NEEDHAM PLANNING BOARD Tuesday, February 2, 2021 7:15 p.m.

Re: Definitive Subdivision Application

390 Grove Street

STORMWATER REPORT & DEFINITIVE PLAN COMMENTS

2020-12-07

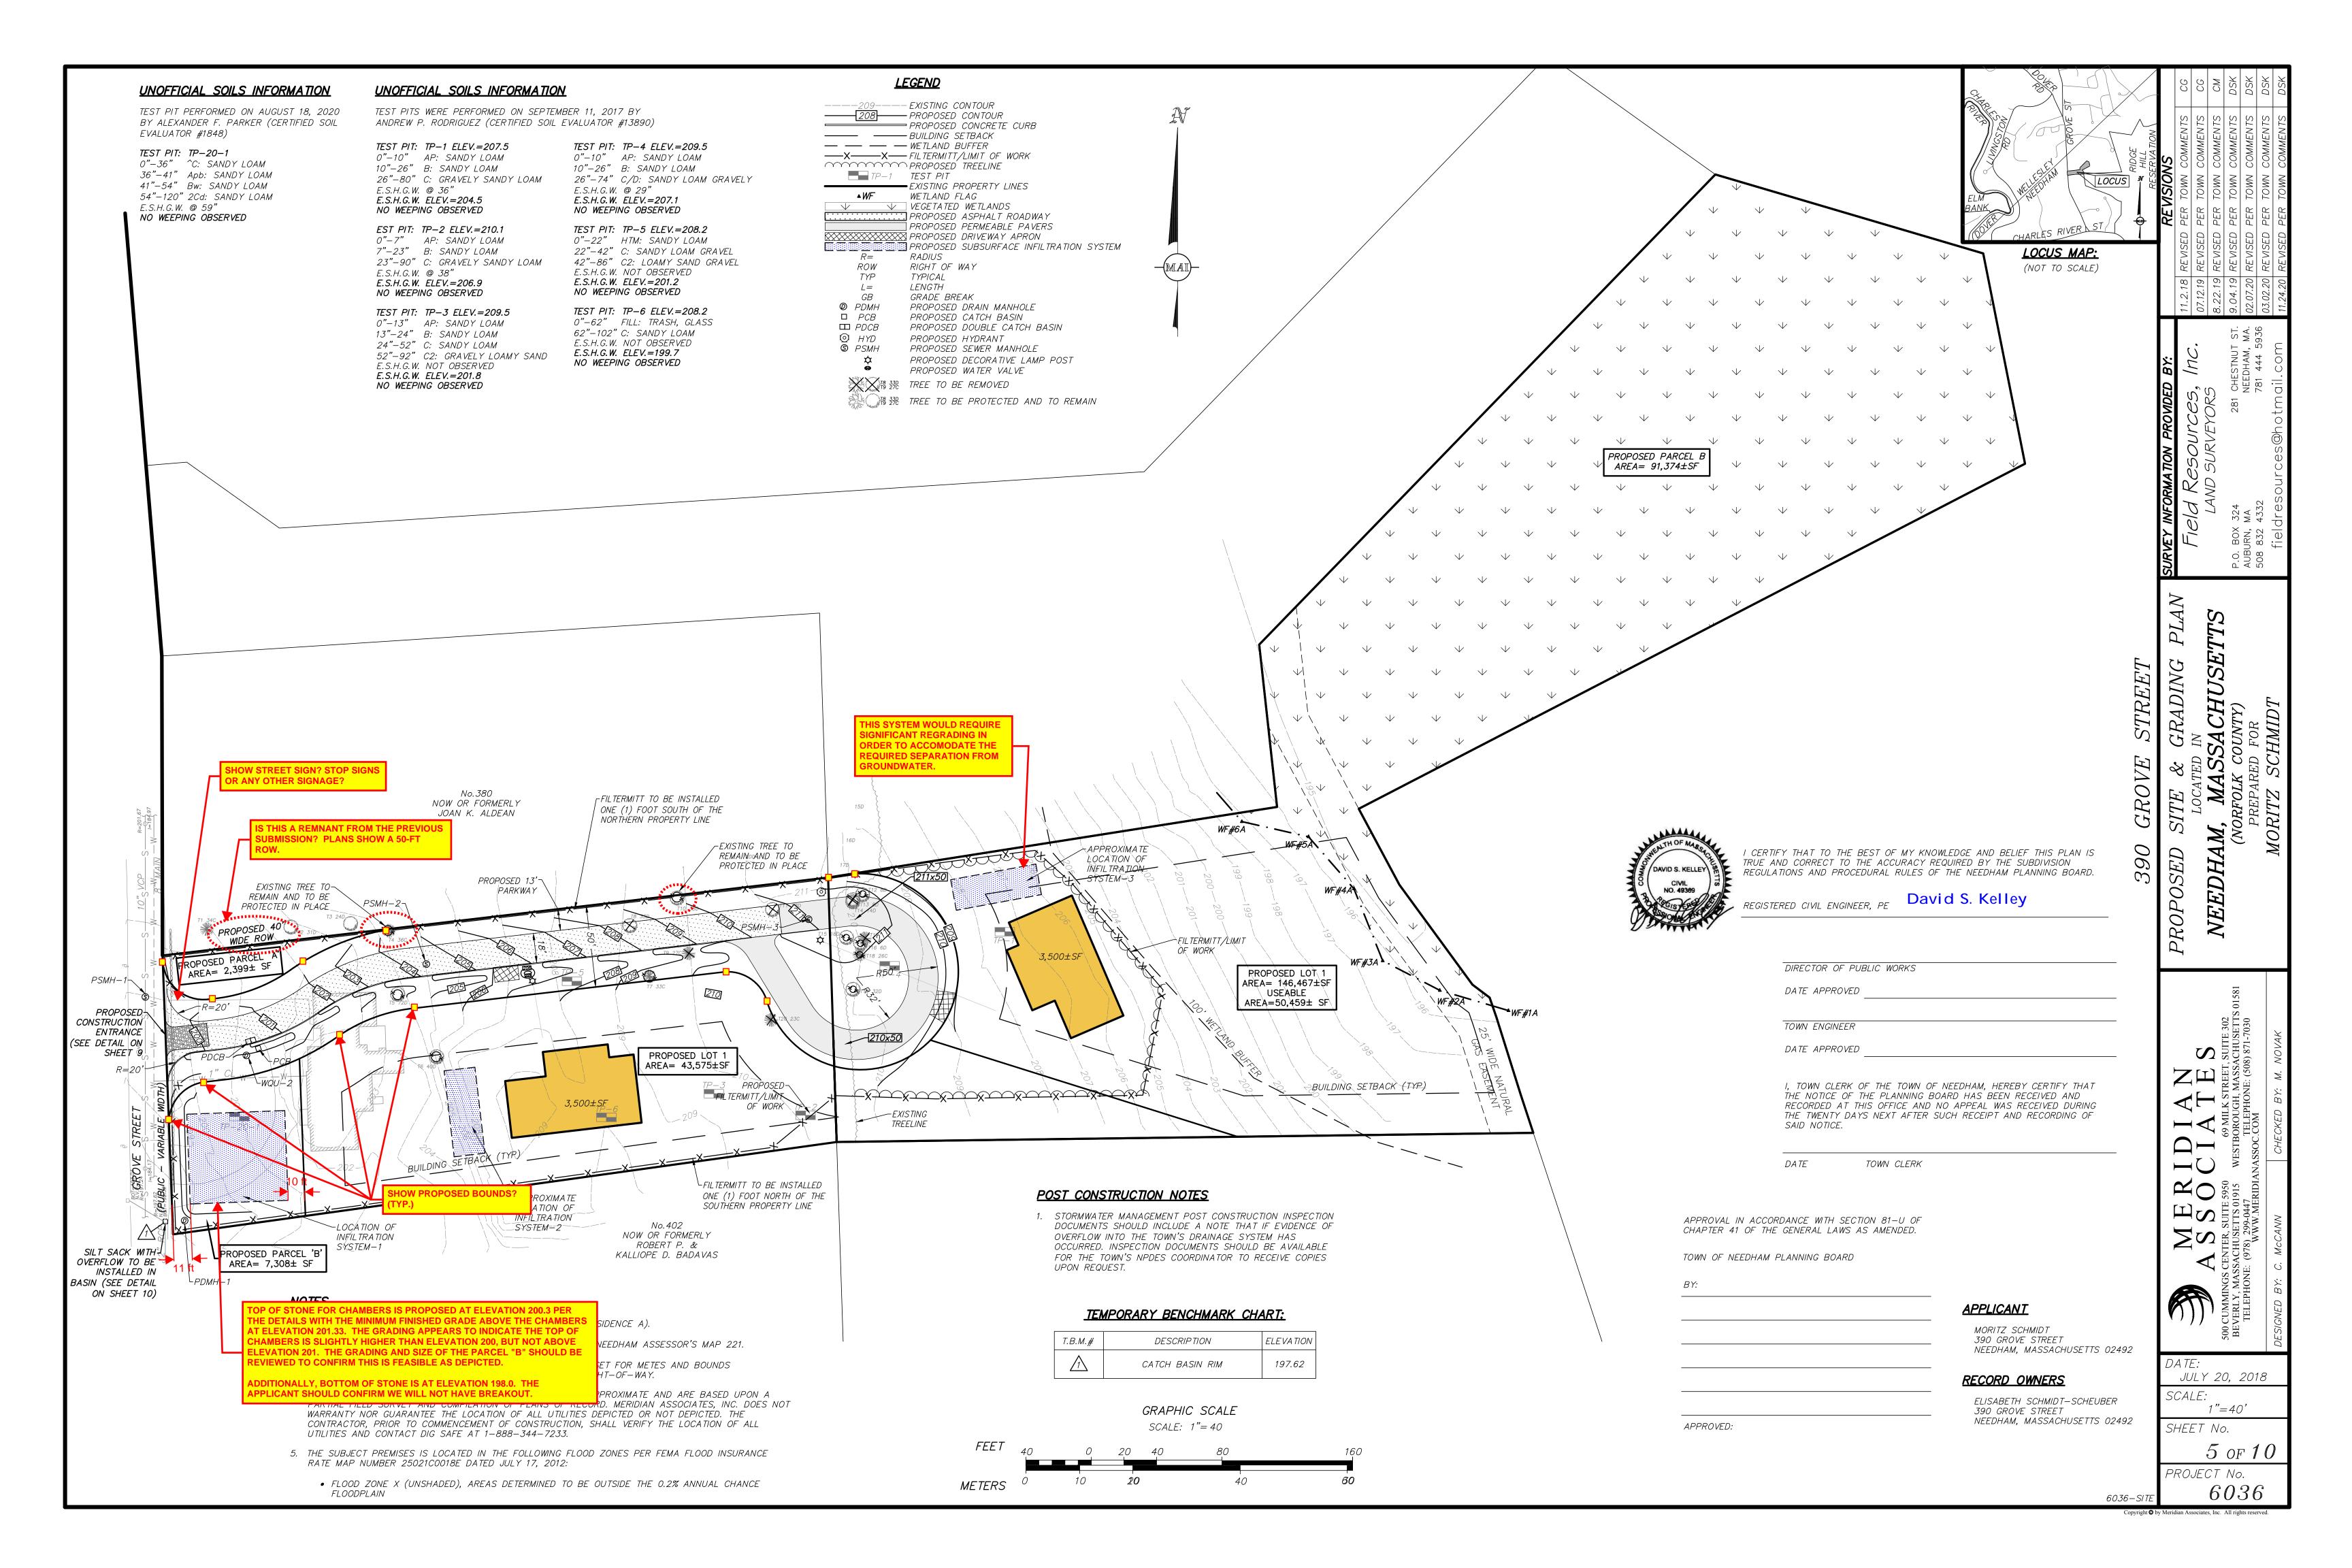
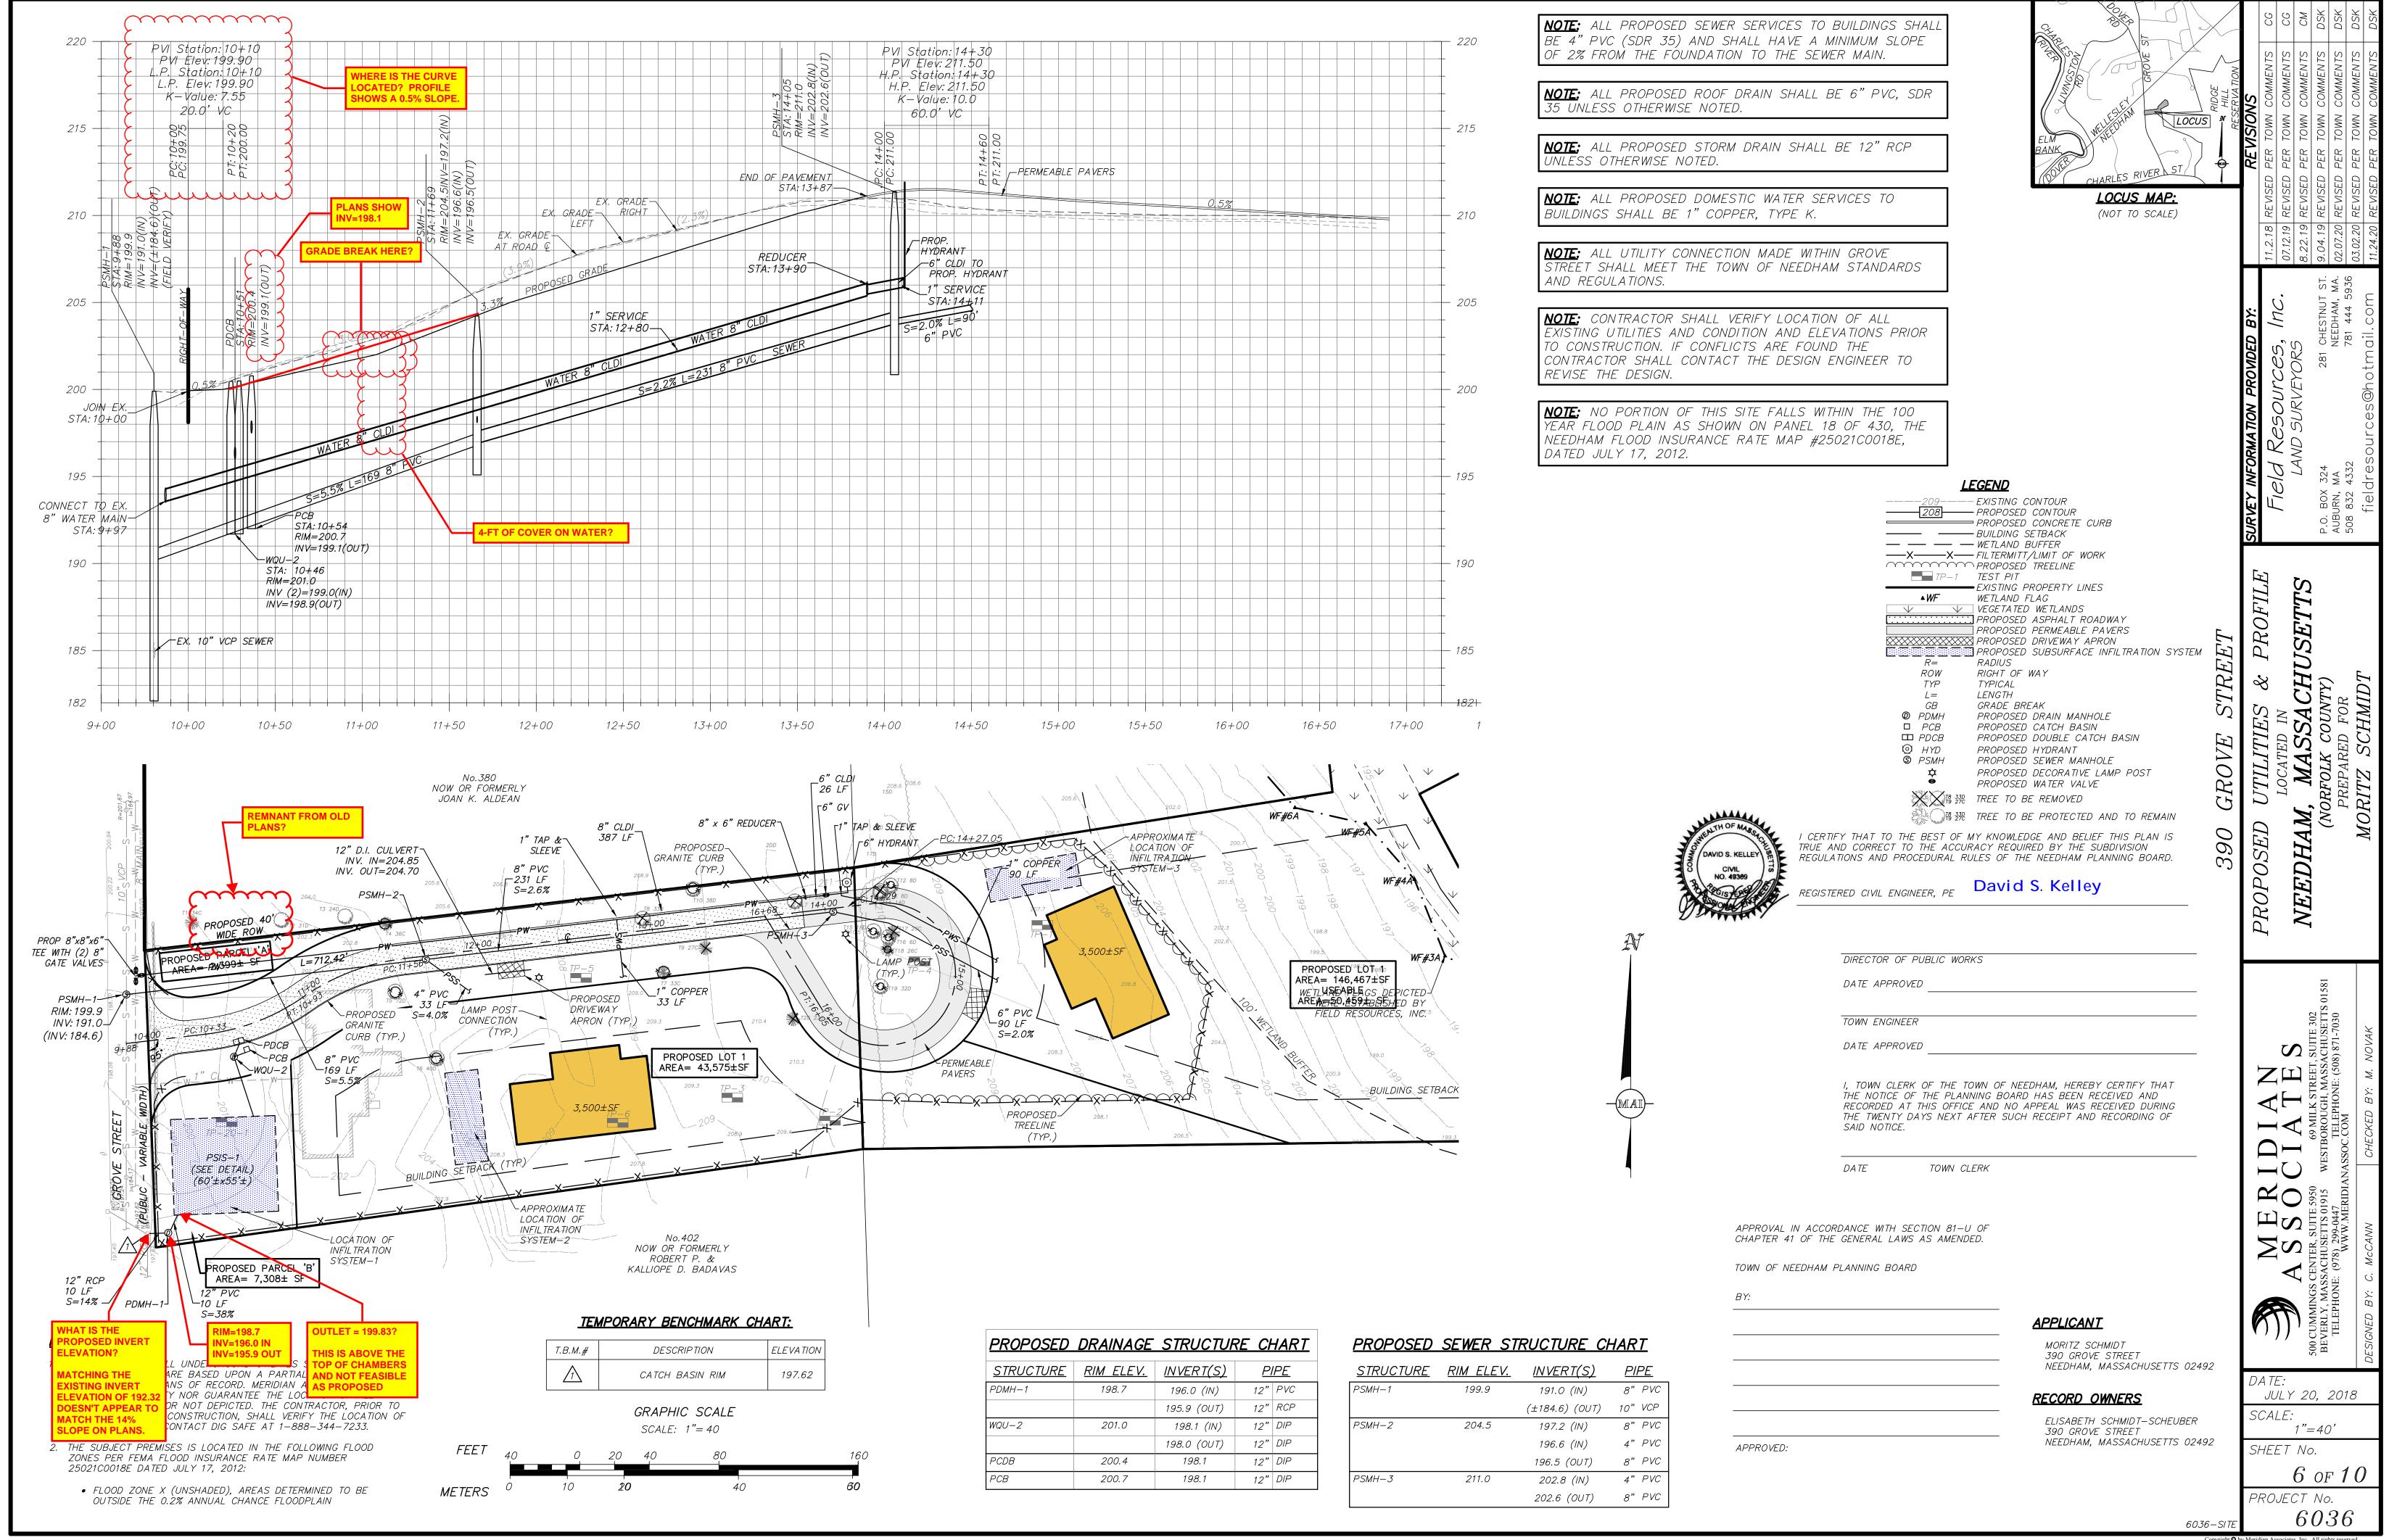
2. Per section 3.3.4 of the subdivision regulations, "Street jogs with centerline offsets of less than 125-ft, streets with varying widths and reverse curves shall be avoided." The By Right Subdivision Plan (sheet 3 of 10) and Proposed Site and Grading Plan depict a street centerline jog of approximately 30-ft at the intersection with Grove Street along with a reverse curve in order to achieve this jog both of which are in conflict with the subdivision requirements.

4. Per Section 3.3.1 of the subdivision regulations, "The grade of a street within 50-feet of a street intersection shall not exceed 1% to provide a level area for traffic safety." The Proposed Utilities & Profile Plan (Sheet 6 of 10) identifies that the road contains only a 20-foot long section of roadway that has a slope less than 1%, which is less than the 50-foot requirement.

9. The By Right Subdivision Plan (Sheet 3 of 10) does not depict proposed grading or stormwater management features that would be required for the design as depicted on the by-right plan. Additionally, the proposed sidewalks depicted on this plan are very close to the existing trees to

10. The By Right Subdivision Plan (Sheet 3 of 10) and most of the other plans identify both buildable parcels as Lot 1 and there is no Lot 2. This needs to be corrected.

11. The Lotting Plan (Sheet 4 of 10) has a number of significant inconsistencies with the remainder of the Definitive Plans. These include the following: identifying Parcel B as part of Lot 2 at the end of the proposed roadway, whereas the remainder of the Plans identify Parcel B as the remnant parcel north of the subdivision roadway parcel; identifying the remnant parcel south of the subdivision roadway as Parcel A, whereas the remainder of the Plans identify this as Parcel B; not labeling the remnant parcel north of the subdivision roadway. The Lotting Plan as presented is not complete or accurate and cannot be approved as currently presented.

15. The top of stone for Infiltration System 1 is proposed at elevation 200.3 per the details on Sheet 10 of 10. The minimum proposed finished grade above the chambers is identified to be elevation 201.33. The grading depicted on the Proposed Site & Grading Plan (Sheet 5 of 10) appears to indicate the top of chambers is slightly higher than elevation 200, but not above elevation 201 which would not provide the required amount of cover. The surface grades are proposed to slope down immediately adjacent to the proposed stormwater chambers with the surface grade less than the top of stone within approximately 5-ft of the chambers. Additionally, the bottom of chambers is proposed above the existing street grade along Grove Street. The Applicant should confirm there will not be breakout along Grove Street. The grading in the vicinity of the Infiltration System 1 and size of Parcel "B" should be reviewed to confirm this parcel has sufficient size and the drainage system is feasible as proposed.

19. The Proposed Utilities & Profile Plan (Sheet 6 of 10) shows an 8x8x6 tee connection to the existing 8" water main for the proposed 8" water main. This connection is inaccurate as it does not appear that a 6-inch pipe is proposed in this location. Additionally, the waterline appears to have less than 5-ft of cover from station 10+50 to 11+50. This should be addressed.

20. The profile included on the Proposed Utilities & Profile Plan (Sheet 6 of 10) depicts a proposed grade of 3.3% presumably along the centerline of the roadway, although the profile line appears to have a number of grade breaks at approximate stations 10+20 and 11+40. There is no information included regarding these apparent grade breaks. Furthermore, a 20-ft vertical curve is identified from station 10+00 to 10+20, although the profile appears to indicate that the centerline grade at this location is set at a uniform slope of 0.5%. These inconsistencies should be addressed.

21. The Revision Block on the Record Conditions Plan of Land (Sheet 2 of 10) is unclear and has overlapping text. This should be corrected for the record.
